CITY OF TARPON SPRINGS
PLANNING & ZONING DEPARTMENT

Subject: **Anclote Harbors; Staff report addendum to be provided prior to 2nd reading**

ANCLOTE HARBOR

#20-106 [PRELIMINARY PLANNED DEVELOPMENT]

Figure 8
P.M. Peak-Hour Background Traffic
Anclote Harbor Development
Tarpon Springs, Florida

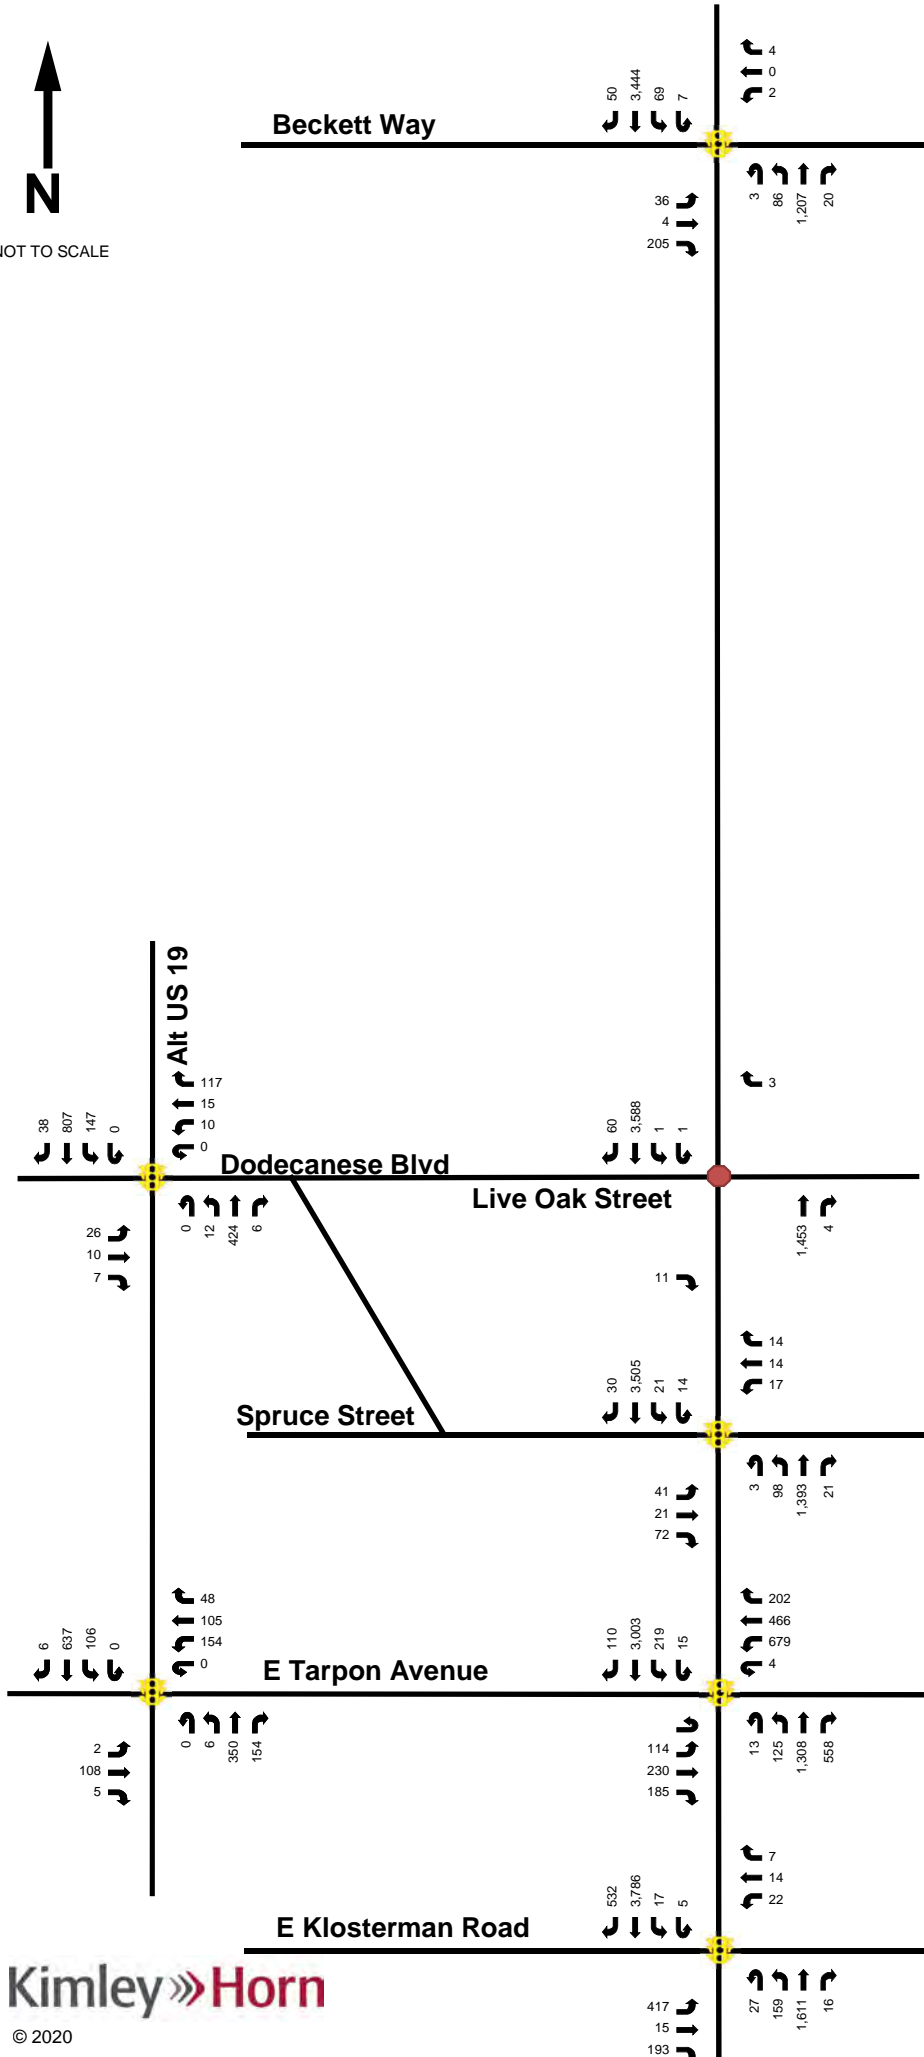
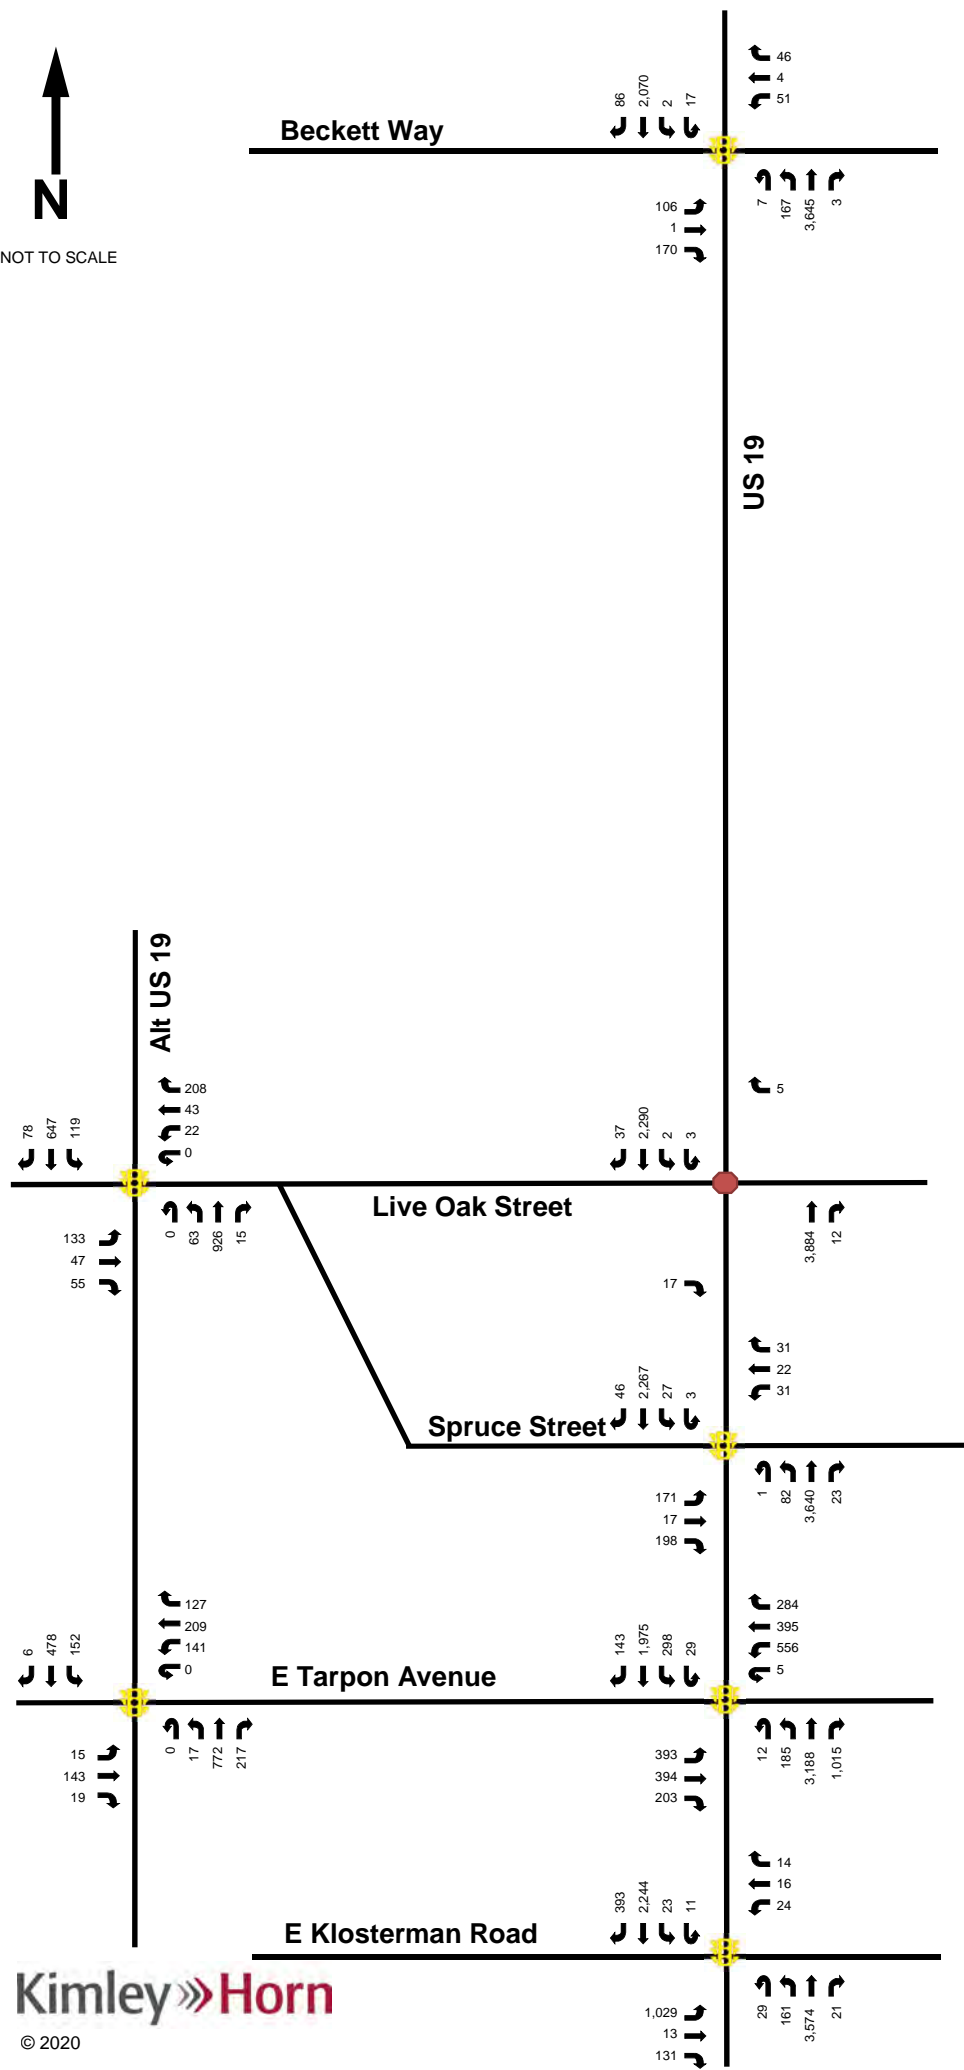
Comment 8: Typical Comment - Determine if comments on Figures 2 through 4, would affect the traffic volumes shown in Figures 5 through 8, and Figures 10, 11.

Comment 9: Typical Comment - Add link volumes on Figures 5 through 8 between all Study Intersections.

Figure 9: Offset Left-Turn Median Opening Example

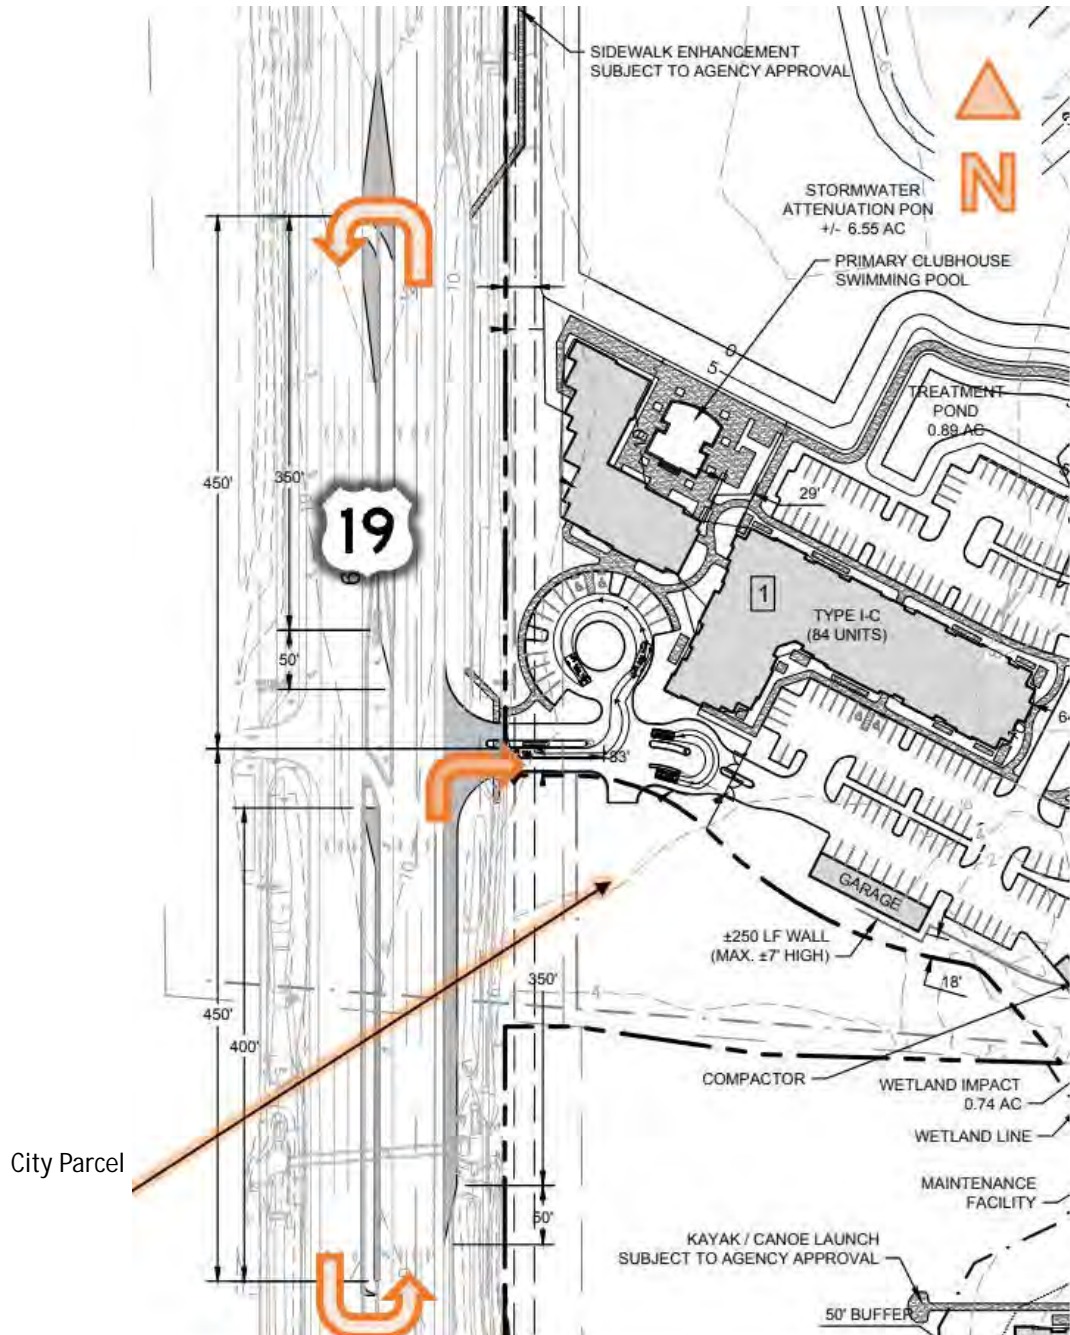
Response: Figure 9 in the report has been updated to indicate the directional U turn arrows and includes the site plan to clarify the access to/from the site.

Response Comment: Response accepted. The Preliminary Development Plan (PDP-01) was not updated but Figure 9 is sufficient.

Figure 10
A.M. Peak-Hour Total Traffic
Anclote Harbor Development
Tarpon Springs, Florida

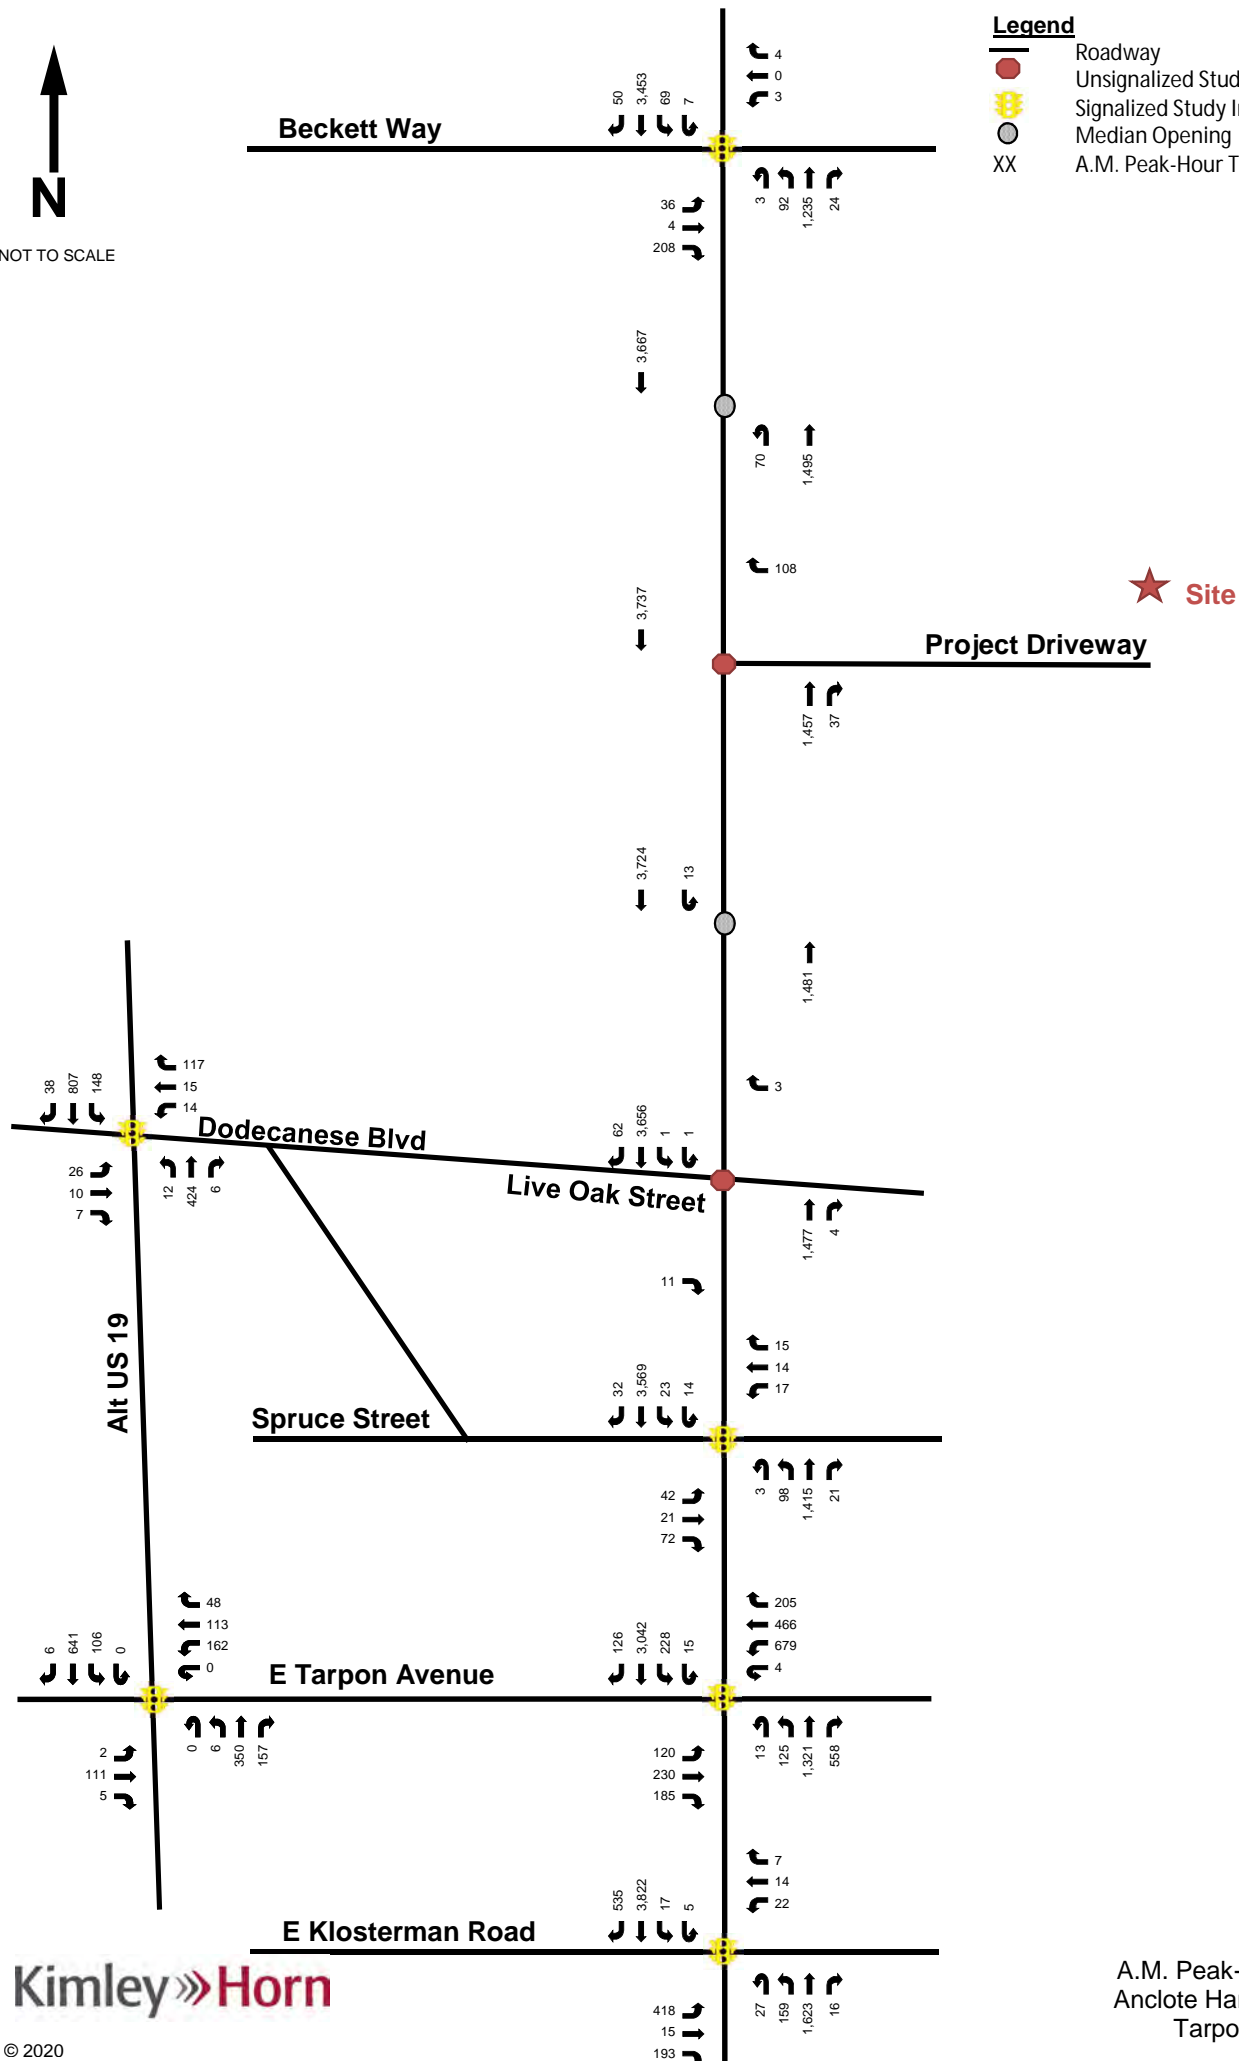
Response Comment: Noted that the figures are not to scale, but Figures 3, 5, 7 and 10 do not match the other figure geometry for Spruce Street and Dodecanese Blvd. The geometry should be consistent among all Figures.

Comment 10: Comments on Figure 10, 11-
